State of Ohio Environmental Protection Agency

Re: Storm Water Inspection at Strike City

This letter is written in follow-up to a construction storm water inspection by Katie Anderson and Sean Tyler, of the Ohio EPA, at Strike City located at Windmill Drive, South of Old Diley Road in Pickering Ohio on June 23, 2009. The purpose of the inspection was to evaluate compliance with the General Storm Water Permit Associated with Construction Activities. During the inspection, we noted the following:

Figure 1.

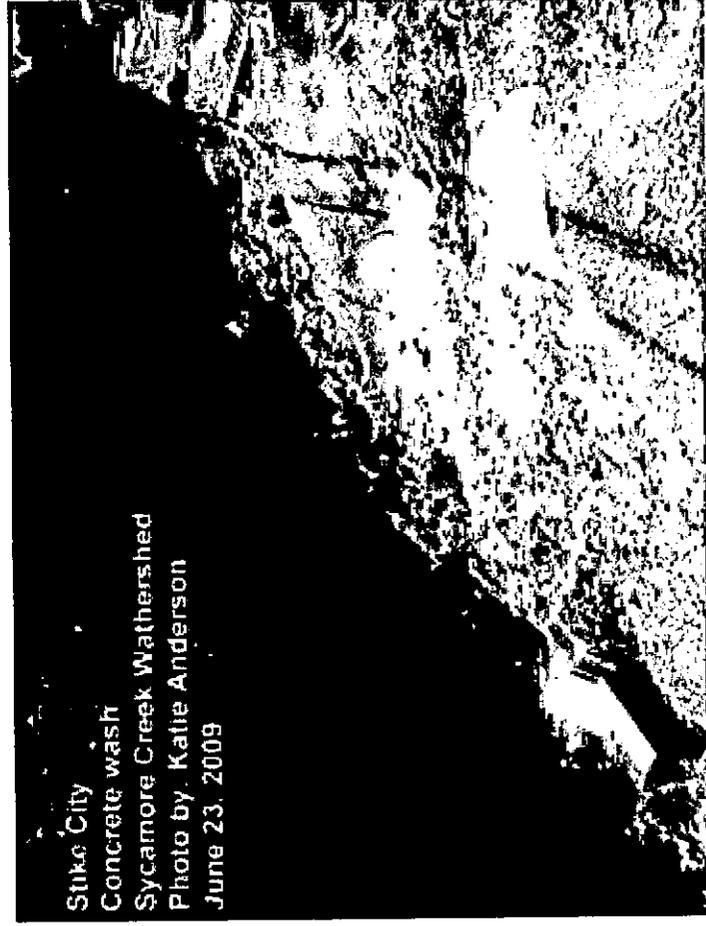
- Upon inspection, current perimeter silt fence along the site have failed and will require repair. In particular, silt fence along the back side of the site has failed resulting in sediment run-off exiting the construction site (See Figure 1).
